US 31/M-37 (Division St.) PEL

Public Input Session 3

What do you think about the design alternatives presented at today's open house?

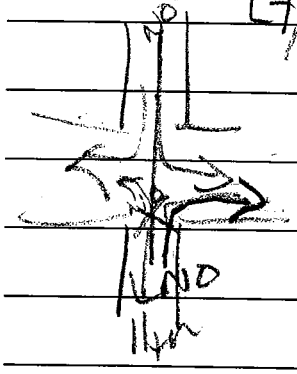
Light at 14th for pedestrian crossing probably a good idea. Need to not allow west traveling Traffic on 14th to go left onto Division. Also No entrance for East bound Traffic ~~onto~~ onto 14th. - into the C. Neighborhood L/R turn into Division only no straight
